CONTRACT CHANGE ORDER NO. 44
 SHEET OF

CONDUIT PLAN

SAS SUPERSTRUCTURE ROADWAY WESTBOUND LIGHTING AND ELECTRICAL SYSTEMS

E-47

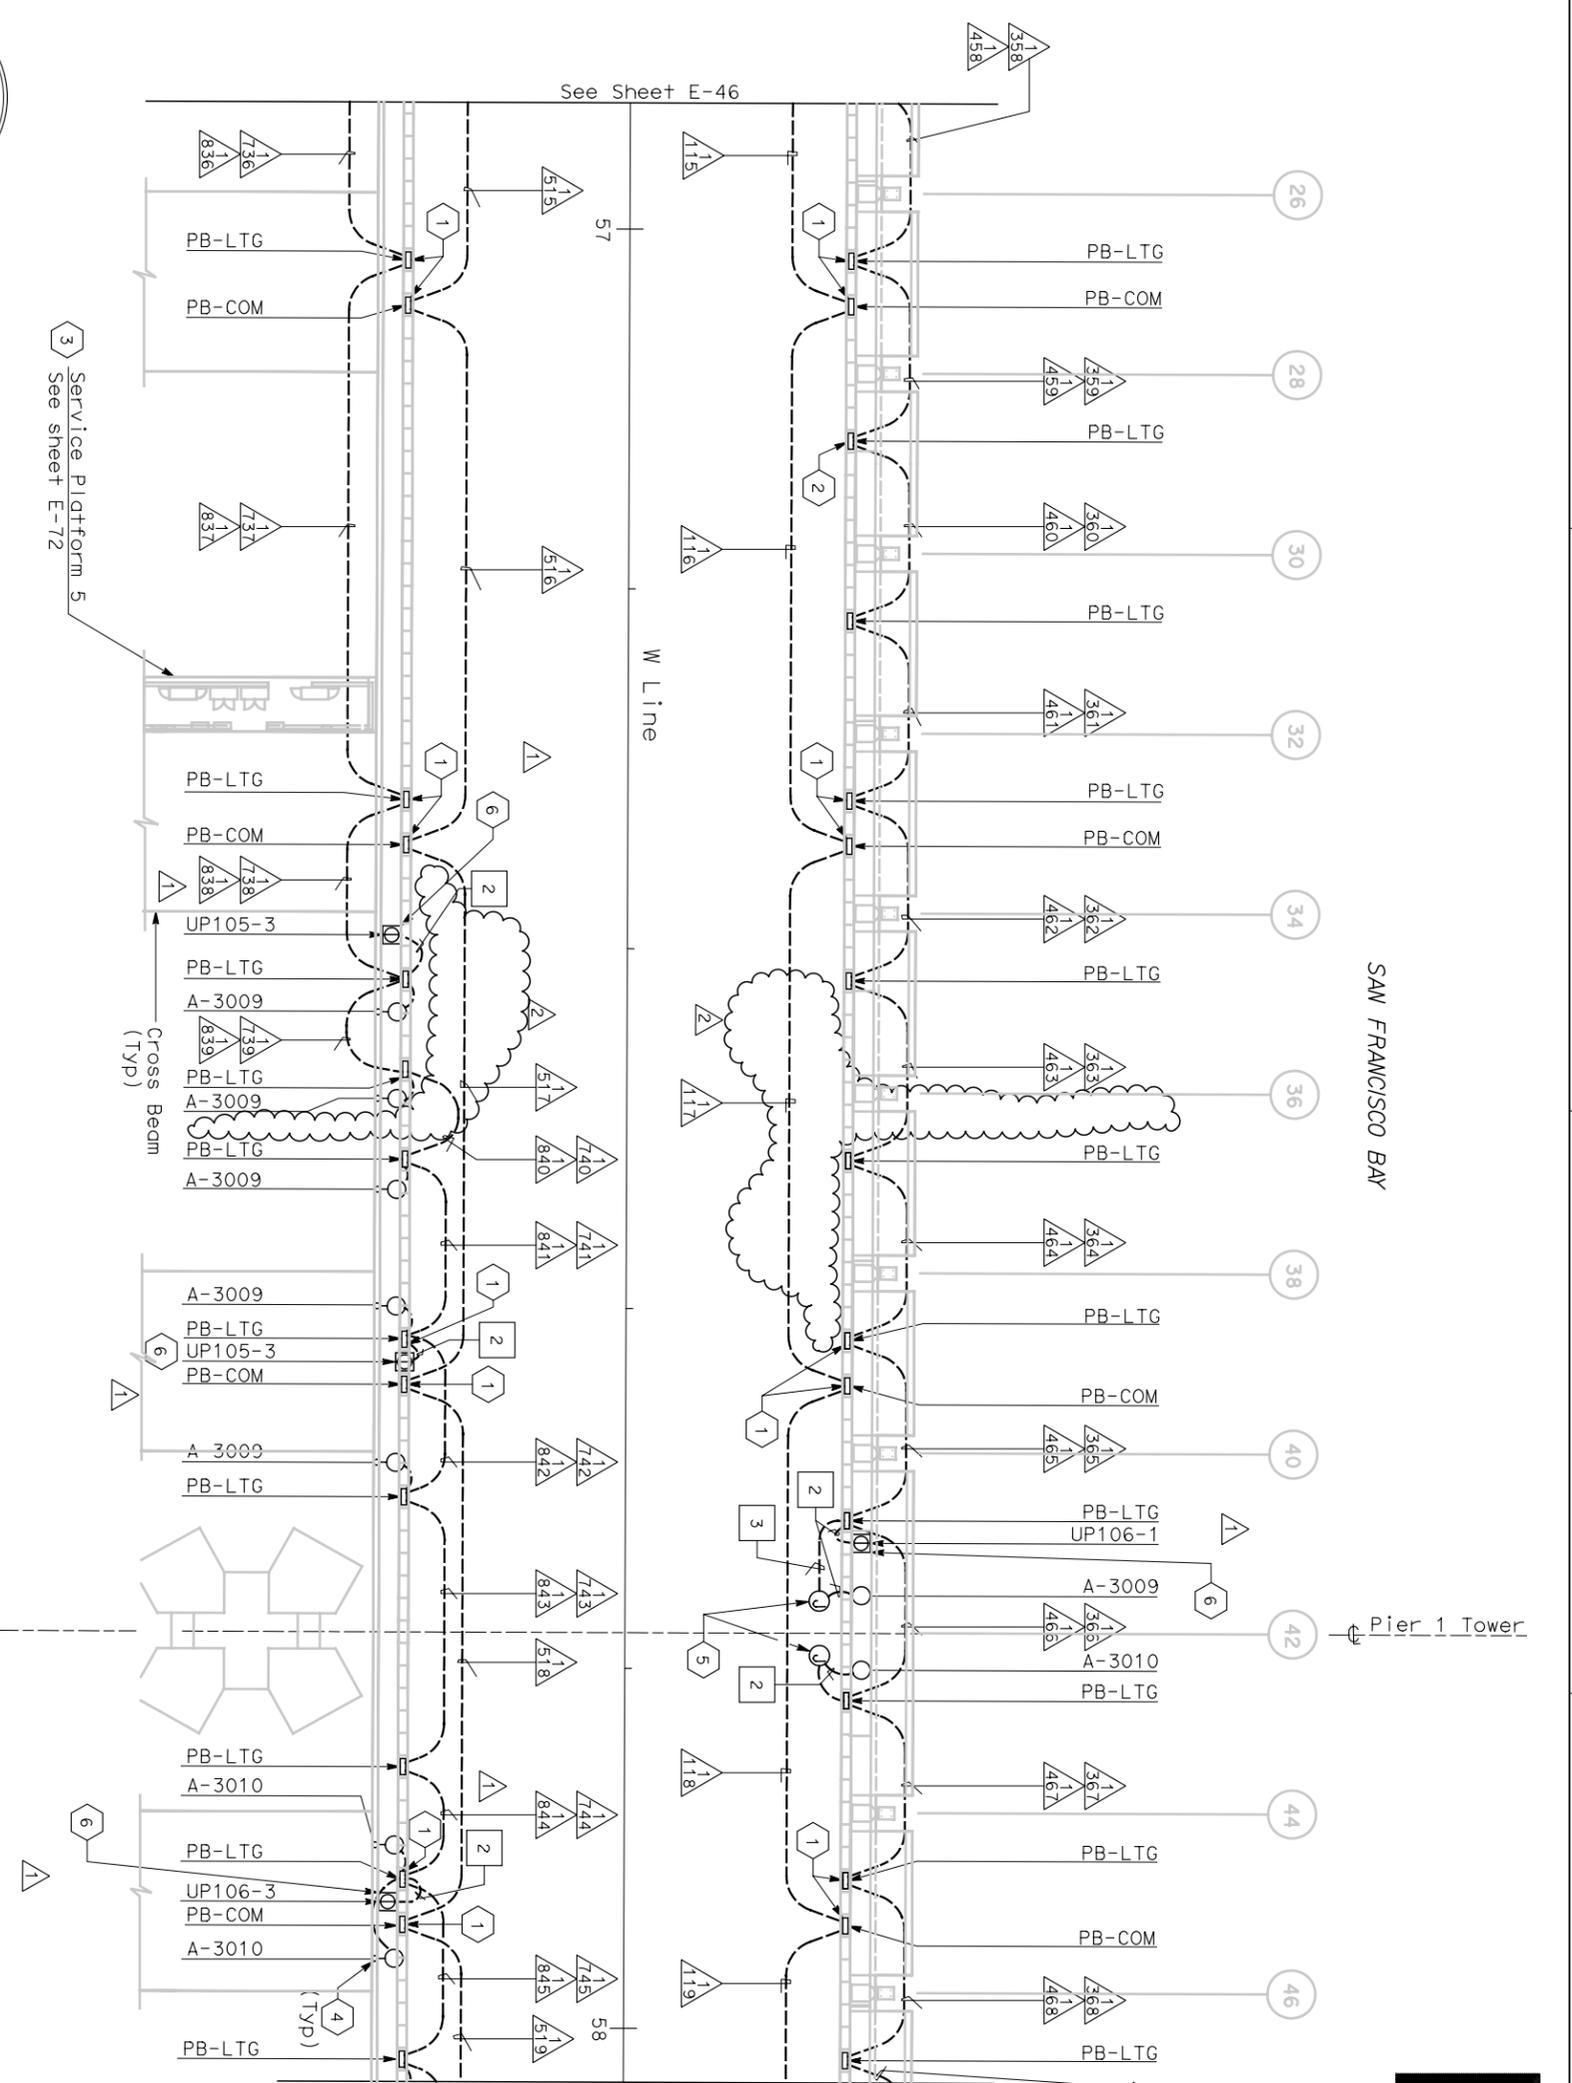
2	11-30-07	Barrier Modifications.	J5	RG	44
1	8-06-07	Electrical modifications.	BM	EL	42
MARK	DATE	DESCRIPTIONS	BY	CK	CCO
REVISIONS
